**LEGAL ADVERTISEMENT
HISTORIC PRESERVATION BOARD
CITY OF PORTLAND
Public comments will be taken at all meetings**

On Wednesday, June 4, 2014 at 5:00 p.m., the Portland Historic Preservation Board will meet in Room 209 of City Hall to review the following items:

**HISTORIC PRESERVATION BOARD
CITY OF PORTLAND, MAINE**

**PUBLIC HEARING
1 CARROLL STREET**

1 EAST ELEVATION
2 SCALE: 1/4" = 1'-0"

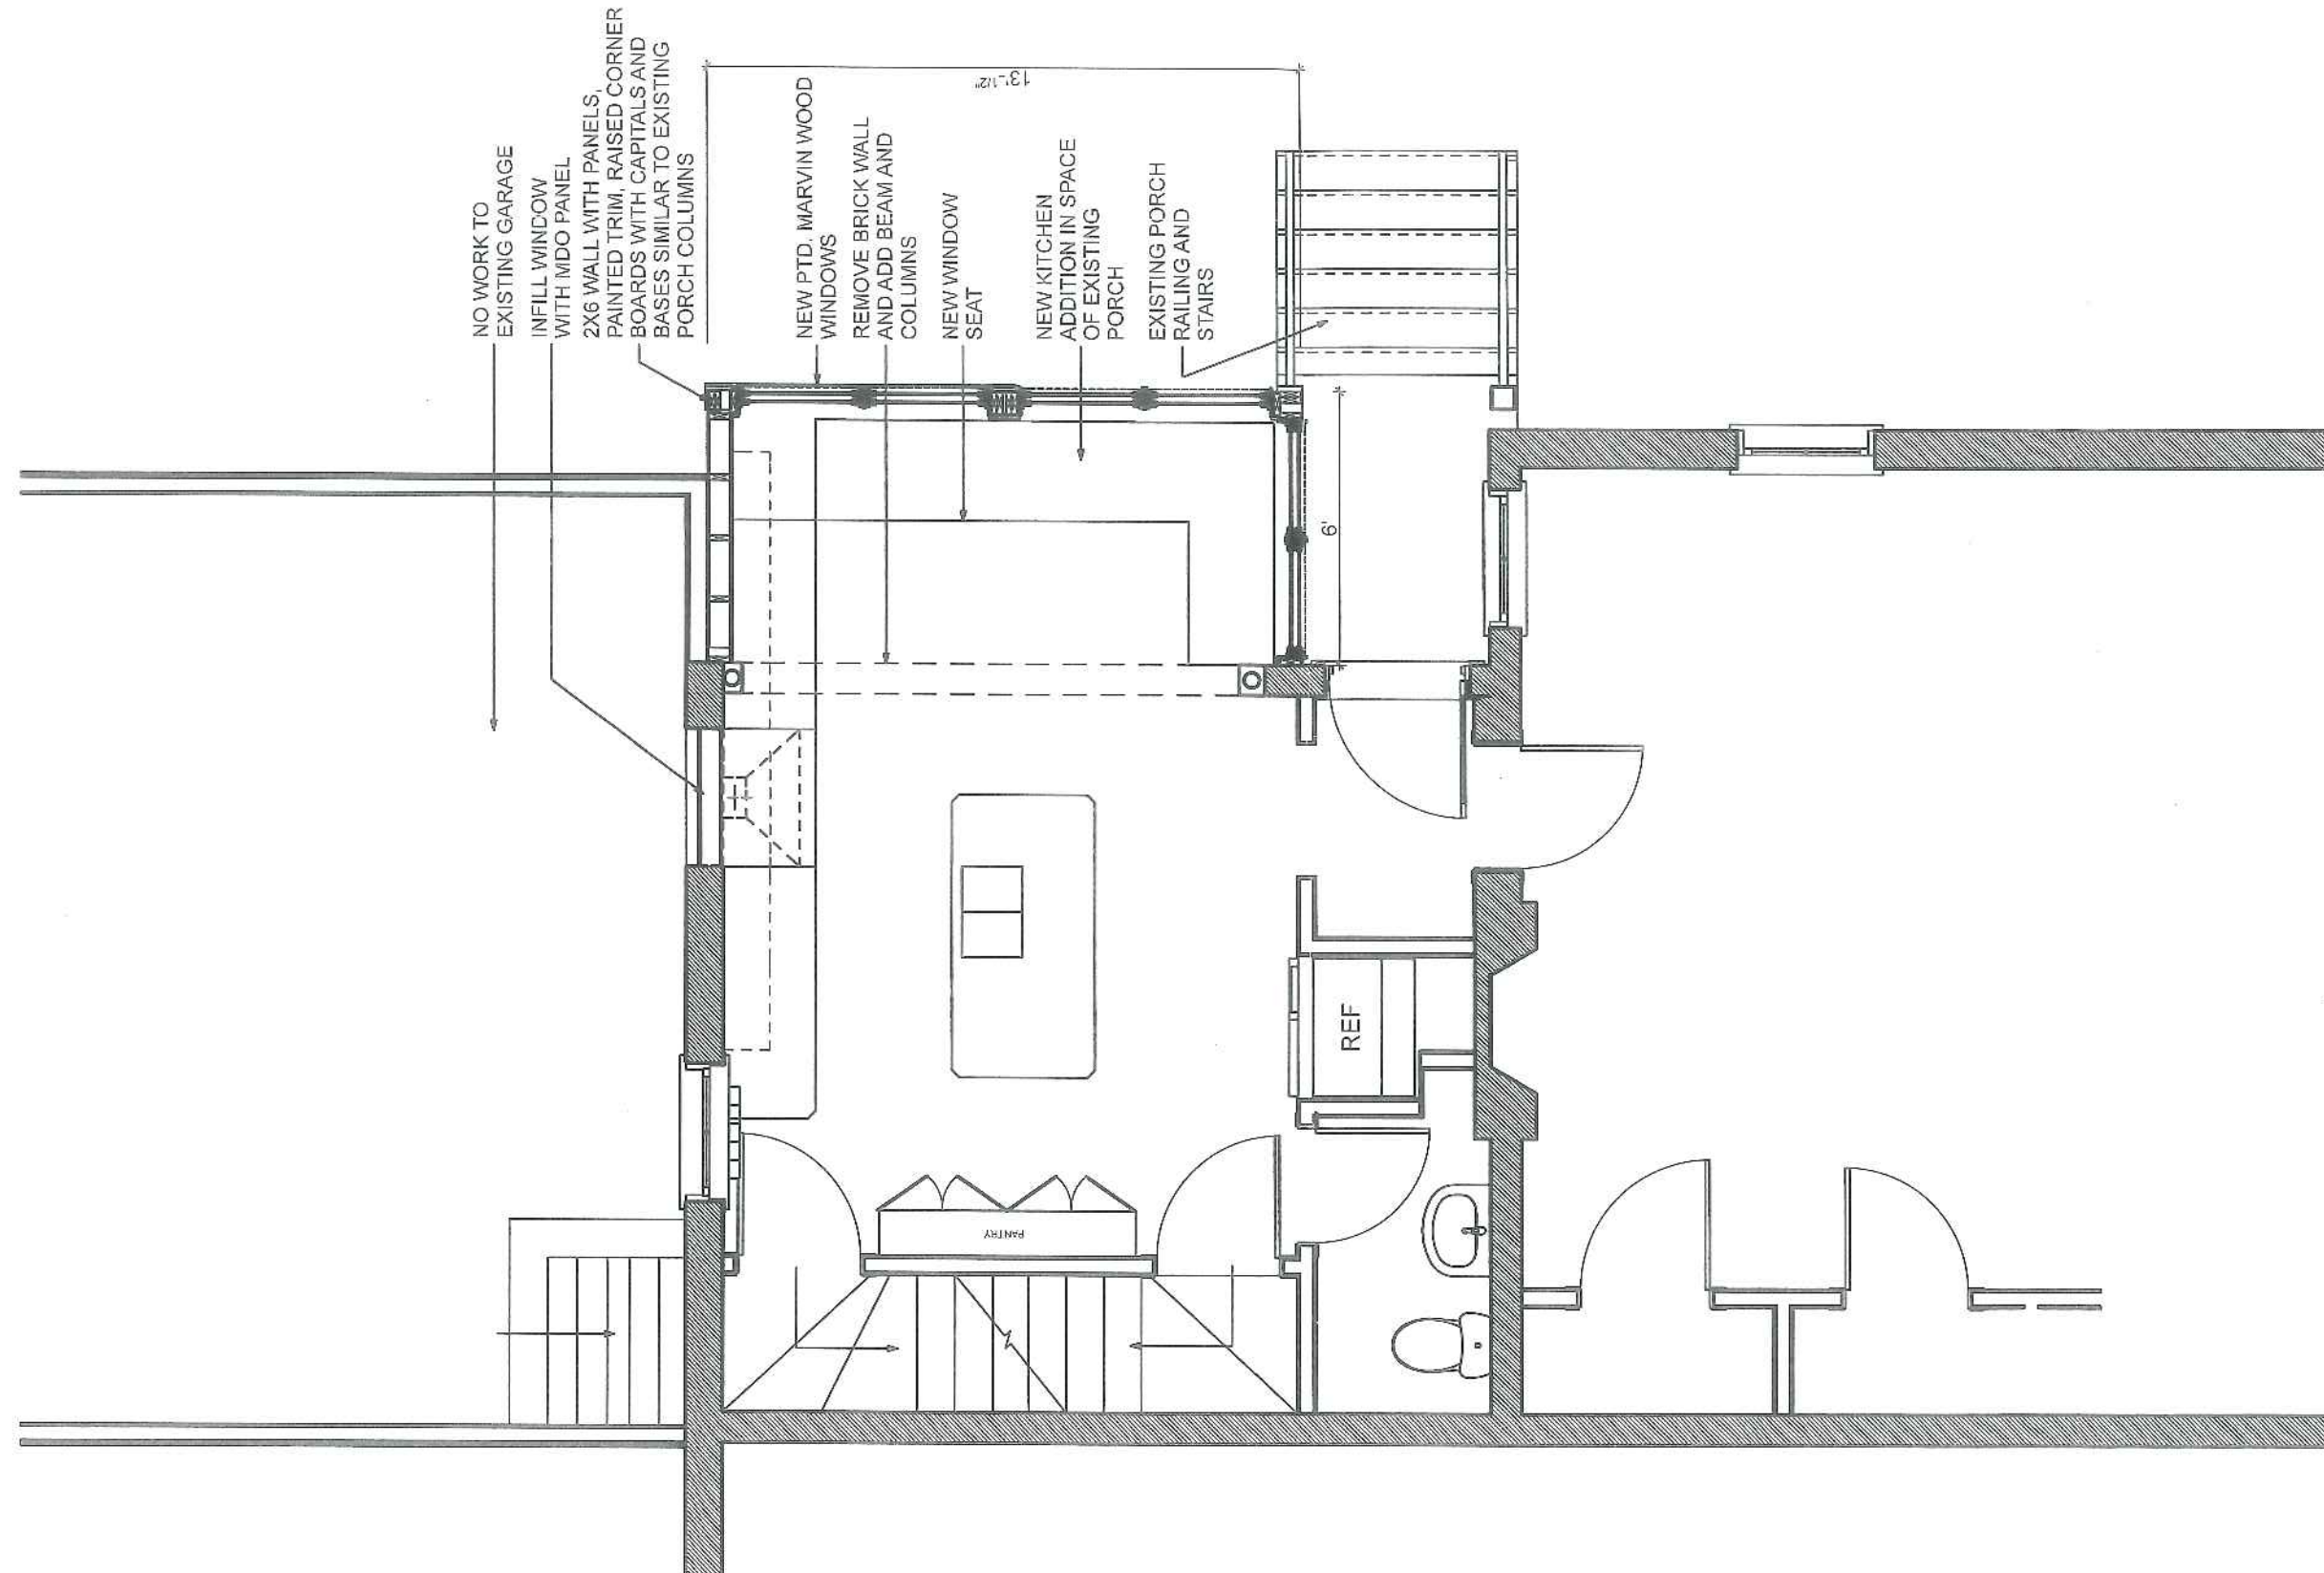
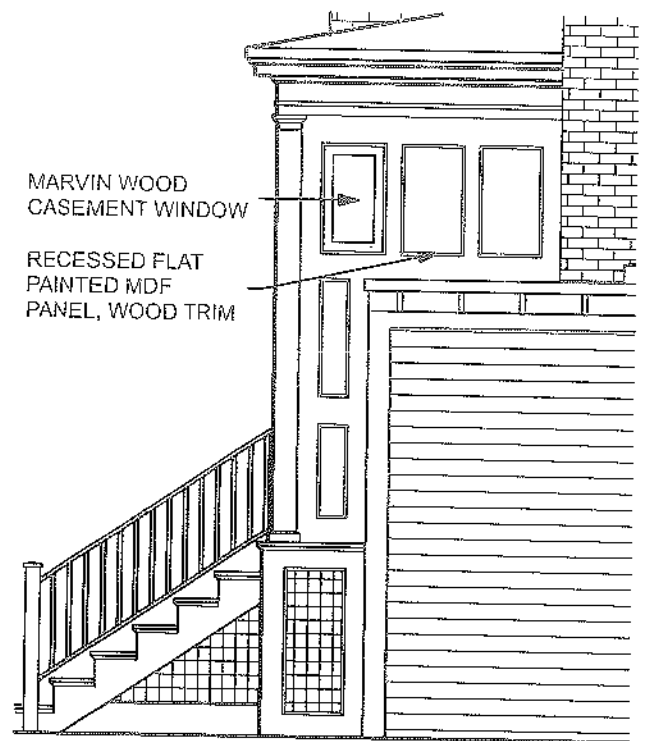
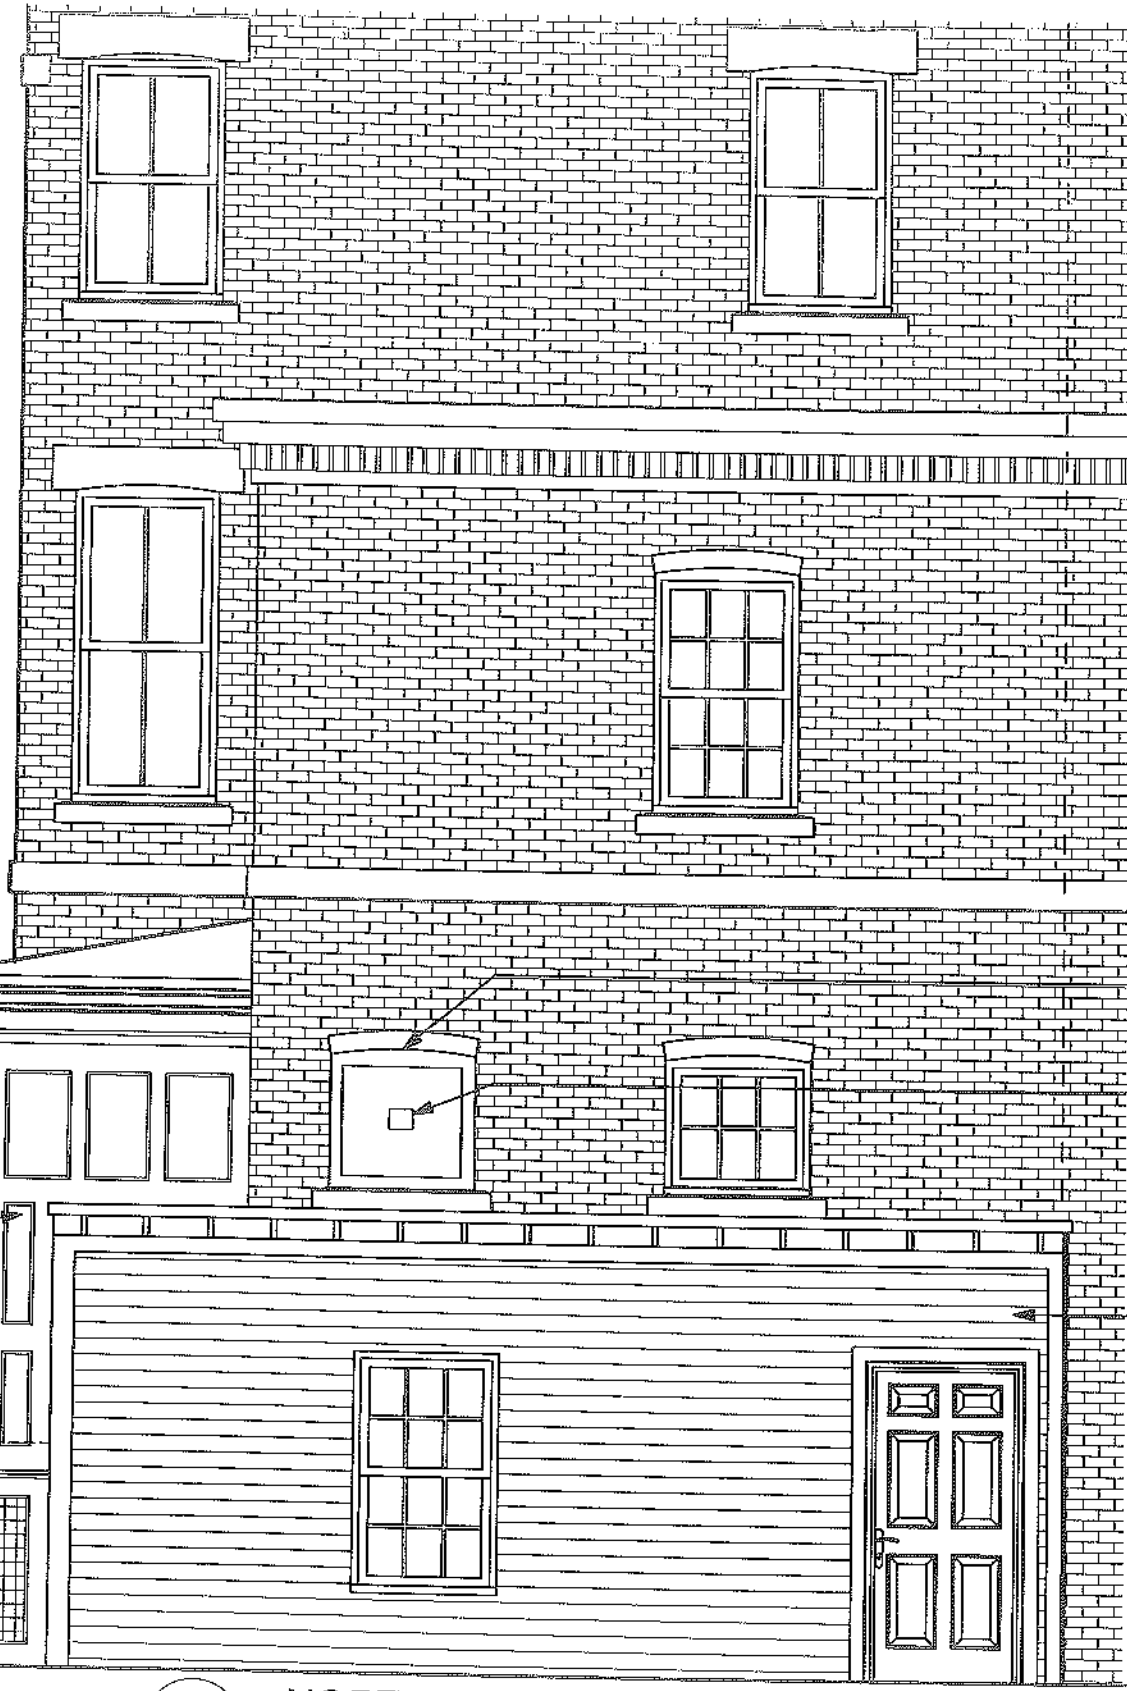
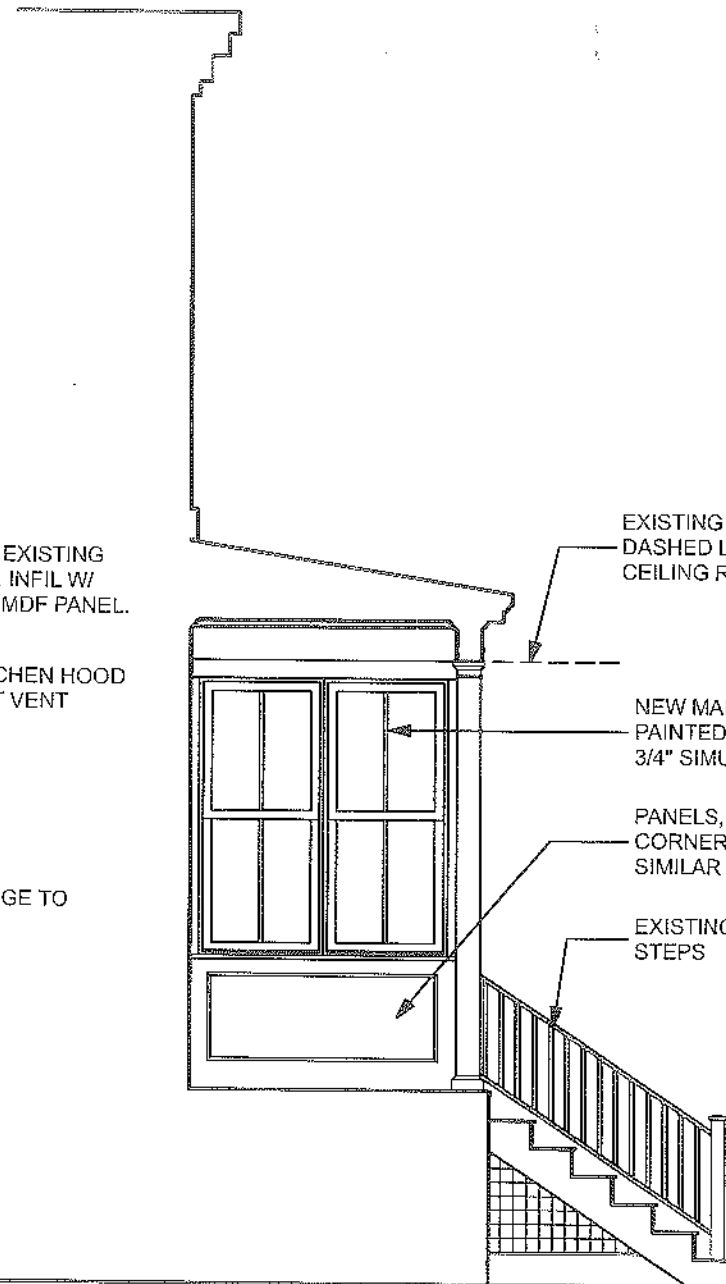
Mr. Whipple's description of the project revisions discusses a number of the points raised at the January 12 meeting, with the most notable design changes appearing on the east and north walls of the infill. The wall facing Thomas Street is more formal, with the addition of a central, full-height post and panels instead of clapboard below the windows. A panel also replaces clapboards on the south side, in the entry alcove. On the north side a series of panels is proposed, with the possibility of one them being replaced by an operable window. Little change is visible inside, except where posts are shown at the walls on either side where the exterior brick wall is to be removed.

The changes to the east and south elevations appear to be a positive response to the concerns raised at the January Board meeting. The exterior detailing is now both more robust and more formal, drawn from the character of the principal residence and differentiated from that of the garage.

In staff's view, the revised treatment for the north wall appears forced and incongruous—with or without the window option. Although the proposed treatment repeats the use of recessed panels featured on the other porch elevations, the panels are used in a non-traditional fashion and are visually distracting. The Board will want to discuss whether
